SUBJECT: AMENDMENT TO BYRON TECHNICAL SPECIFICATIONS - ACCEPTANCE CRITERIA FOR RHR PUMP PERFORMANCE

AMENDMENT TO FACILITY OPERATING LICENSE

Amendment No. 3
License No. NPF-37

ATTACHMENT TO LICENSE AMENDMENT NO. 3
FACILITY OPERATING LICENSE NO. NPF-37
DOCKET NO. STN 50-454

FIGURE 4.5-1

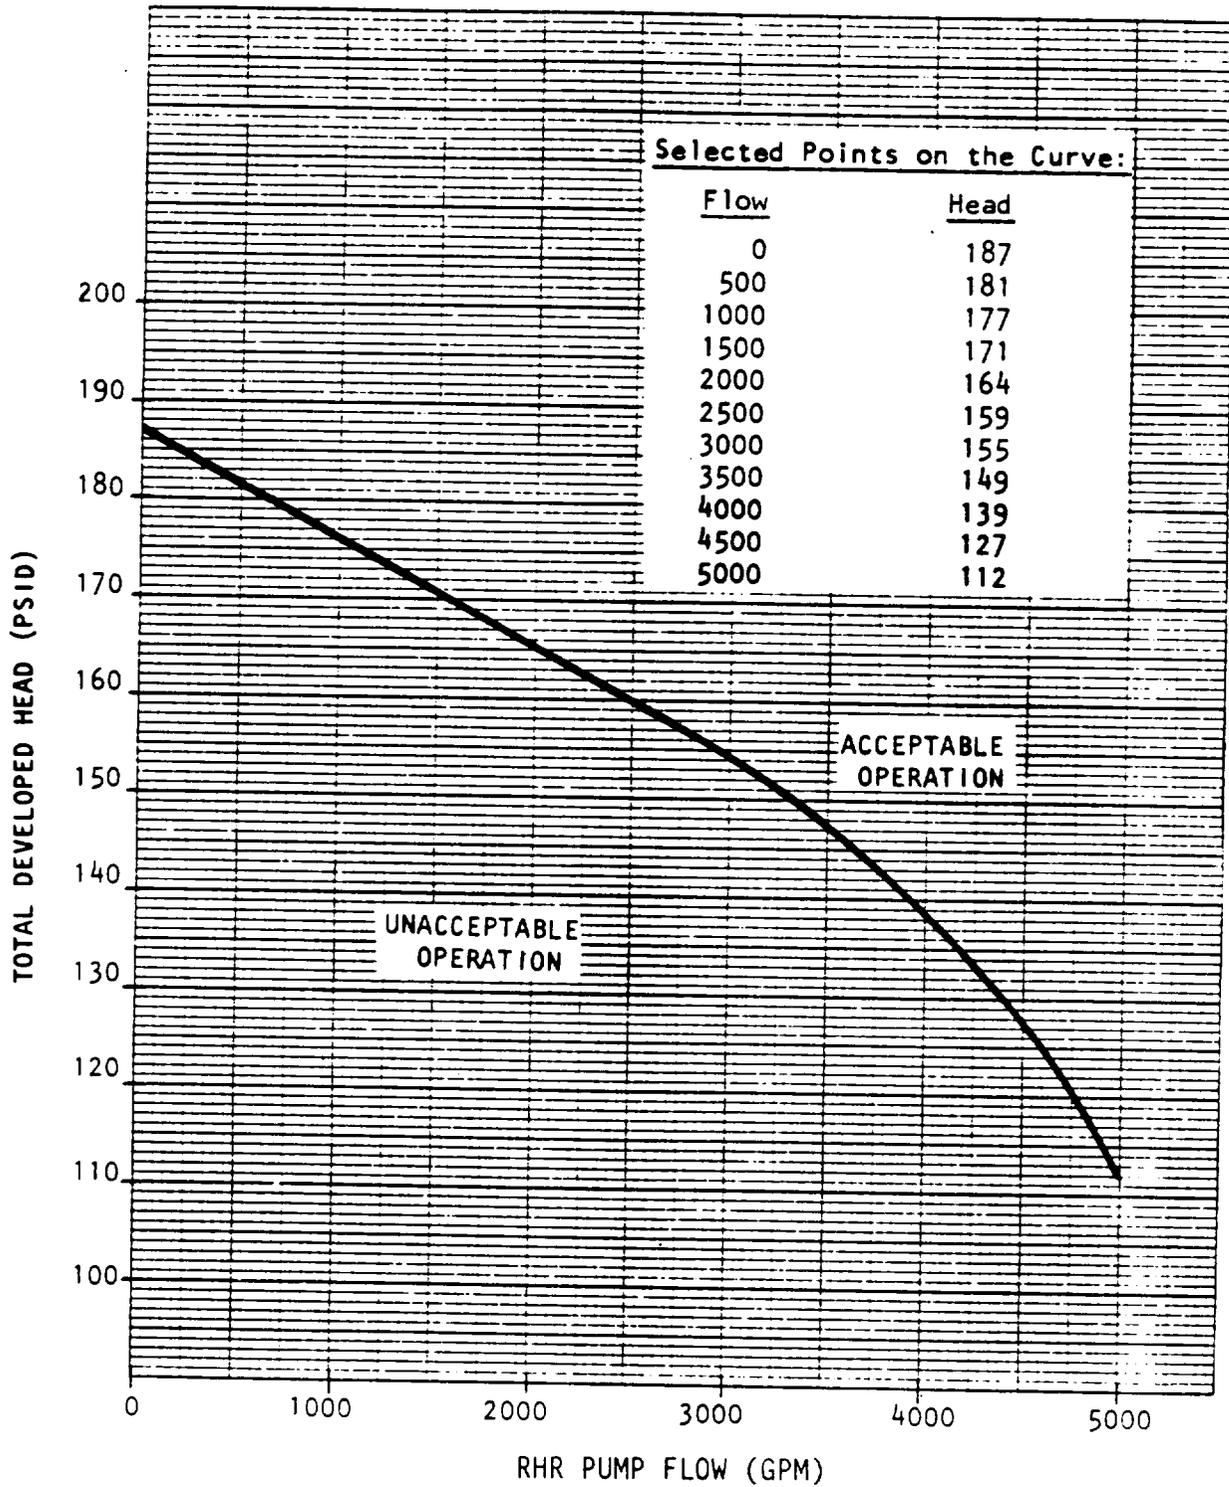
- 1) Centrifugal charging pump \geq 2396 psid,
 - 2) Safety Injection pump \geq 1412 psid, and
 - 3) RHR pump In accordance with Figure 4.5-1

Technical Specification 4.5.2f requires the performance of each Residual Heat Removal (RHR) pump to be periodically tested by verifying that the pump develops a specified differential pressure on recirculation flow. The specified differential pressure corresponds to a flow rate of 500 gpm on the minimum acceptance performance curve. When operating an RHR pump on recirculation flow during this surveillance, the licensee stated that flow rates in excess of 650 gpm have been observed. These higher flow rates correspond to a lower differential pressure. The proposed change, which would allow use of the minimum acceptable performance curve instead of a point on the curve, provides more flexibility in demonstrating the required performance of the RHR pumps.

The staff has evaluated the impact of the proposed amendment on the accident analysis in the Byron FSAR and on the functionality of the RHR system. The pump performance requirements are consistent with the FSAR safety analyses. RHR pump performance in the acceptable region, as defined by the pump performance curve proposed by the licensee, is sufficient to assure adequate reactor coolant flow through the RHR heat exchangers to meet the plant cooldown requirements. The proposed revision to the Byron Station Technical Specifications forwarded by the licensee's letter dated March 11, 1986, as supplemented by letter dated April 11, 1986, are considered acceptable.

By application dated March 11, 1986, as supplemented by letter dated April 11, 1986, Commonwealth Edison Company (the licensee) requested an amendment to the Technical Specifications for Byron Station, Units 1 and 2. The proposed Technical Specification change replaces the minimum differential pressure for the Residual Heat Removal (RHR) pumps with the RHR pump Minimum Acceptable performance curve.
